**AMENDMENTS TO THE DRAWINGS:**

### REMARKS

Fig. 1

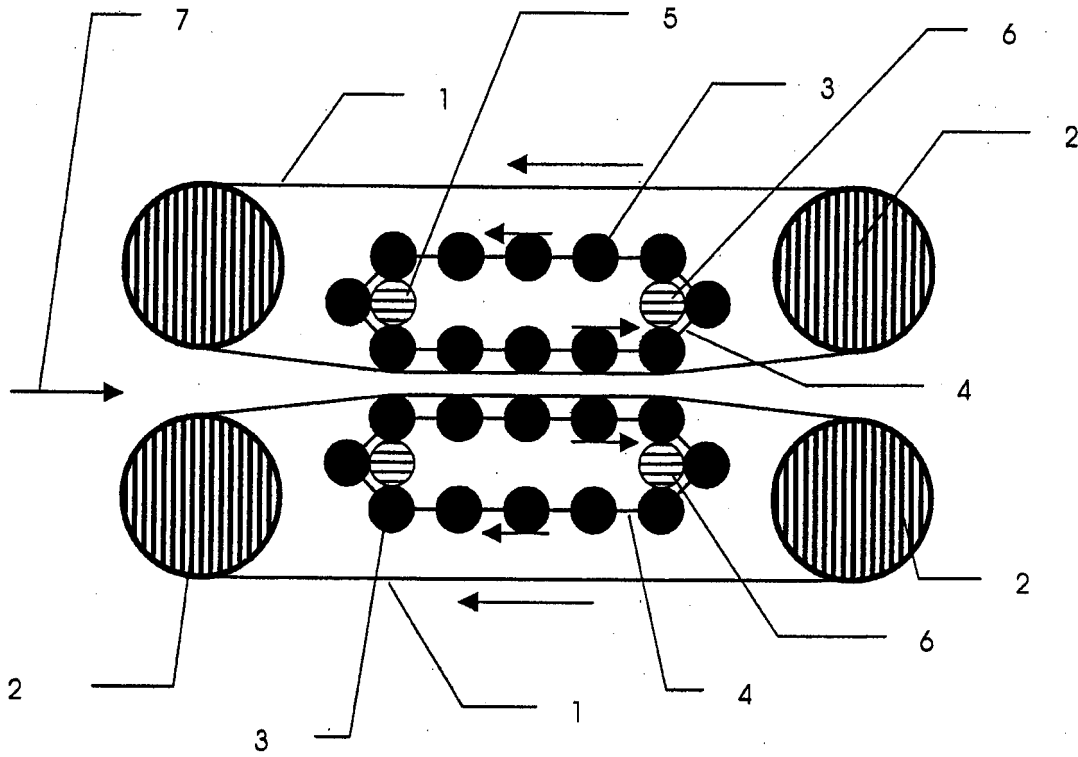
- The "positioning means" in claim 8 corresponds with the output shaft 6 shown in Figure 1 and referenced at page 7, line 8. The positioning function is described more fully in the subsequent paragraph at page 8, lines 29-34 as follows.

Fig. 3

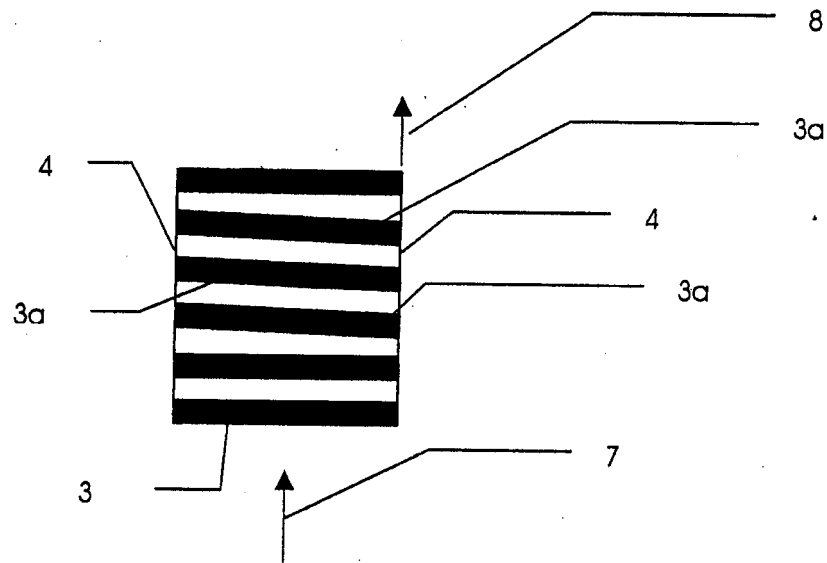
According to the invention, this deviation is counteracted by, for example, temporarily aligning the output shaft not shown in Figure 3 in the opposite diagonal direction, i.e., according to Figure 3, shifting it on the right side in the direction of the arrow 8 in order to thus compensate the slant of the rotating rod 3a.

Fig. 4

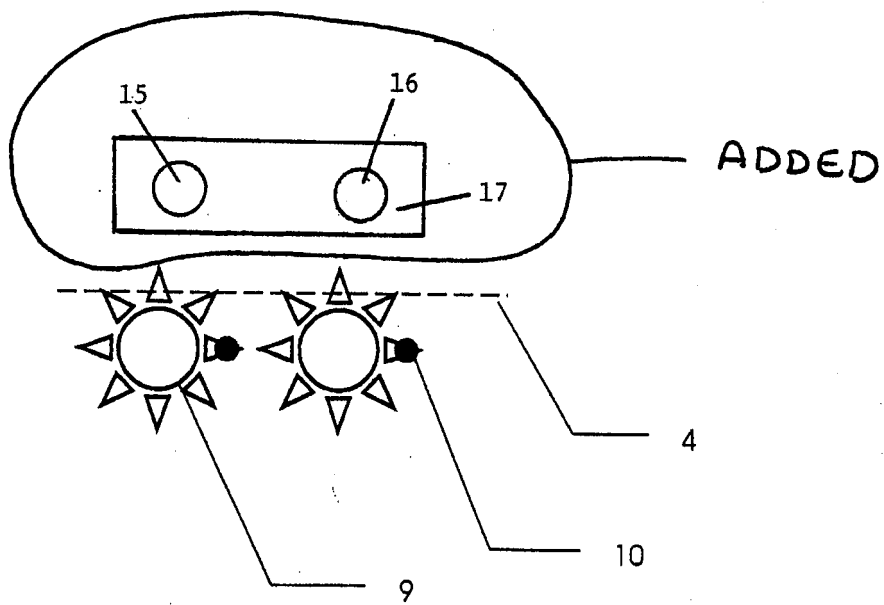
The attached sheets of drawings include changes to FIG. 4. This sheet, which includes FIGS. 3 and 4, replaces the original sheet including FIGS. 3 and 4. In Figure 4, sensors 15 and 16 and evaluation device 17 are schematically shown and added to the drawing.

•The "sensors" and "evaluation device" recited in claims 8 and 10 are now shown in amended Figure 4. Particularly, the sensors 15 and 16 together with the evaluation device 17 are schematically shown. These elements were originally described in the application and the specific discussion at page 9 has been amended herein to include the reference numerals. The amendment of the drawing does not raise new matter issues as the elements and their functions were described in the application as originally filed.
